**VIRGINIA ELECTRIC AND POWER COMPANY
RICHMOND, VIRGINIA 23261**

**VIRGINIA ELECTRIC AND POWER COMPANY
NORTH ANNA POWER STATION UNITS 1 AND 2
PROPOSED TECHNICAL SPECIFICATION CHANGES
IMPLEMENTATION OF ALTERNATE SOURCE TERM**

**DISCUSSION OF CHANGE
PROPOSED ALTERNATE SOURCE TERM LICENSE AMENDMENT**

Figure 3.1-1

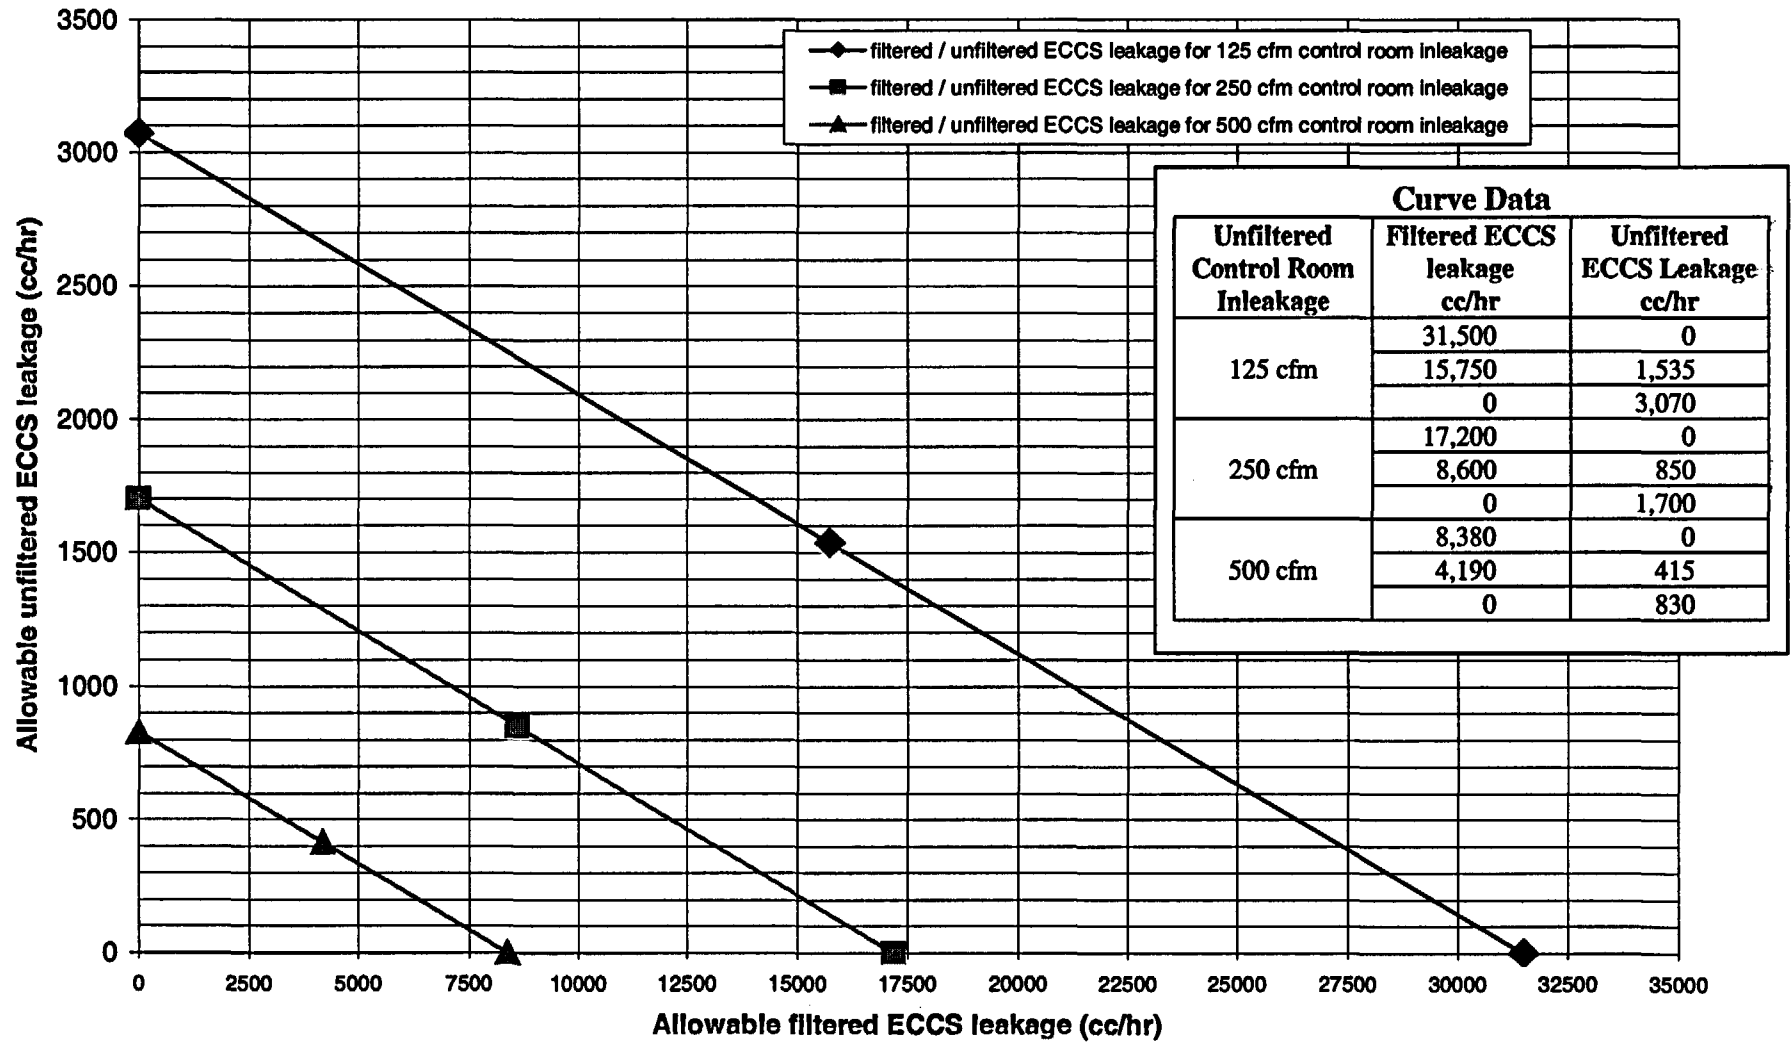
- a. Change the applicability of LCO 3.7.12, "Emergency Core Cooling System (ECCS) Pump Room Exhaust Air Cleanup System (PREACS)," to indicate that the LCO will be applicable according to Specification 5.5.2. A new section, 5.5.2.c, is added to the Specification to develop an ECCS leakage curve that defines PREACS (LCO 3.7.12) applicability during Modes 1 through 4.

A change is proposed to the applicability of LCO 3.7.12 to indicate that the LCO will be applicable according to Specification 5.5.2. A new section, 5.5.2.c, is added to the Specification to develop an ECCS leakage curve that defines PREACS (LCO 3.7.12) applicability during Modes 1 through 4. This curve is intended to represent a set of conditions, including ECCS leakage, MCR inleakage, RWST leakage, etc., that meet the control room dose limits (5 Rem TEDE). It is anticipated that this curve will be revised under 10 CFR 50.59 to address changing operating conditions for ECCS leakage, MCR inleakage, RWST leakage, etc.

RADTRAD-NAI runs were made with combinations of filtered and unfiltered ECCS leakage rates that resulted in total control room doses of 5 rem TEDE when added to doses from containment leakage, RWST leakage, and filter shine. The results of these runs are presented below in graphical form in Figure 3.1-1.

Allowable ECCS Leakage filtered / unfiltered Combined Flows which Generate a 5 REM Control Room dose
(when added to the containment, RWST and filter shine components)
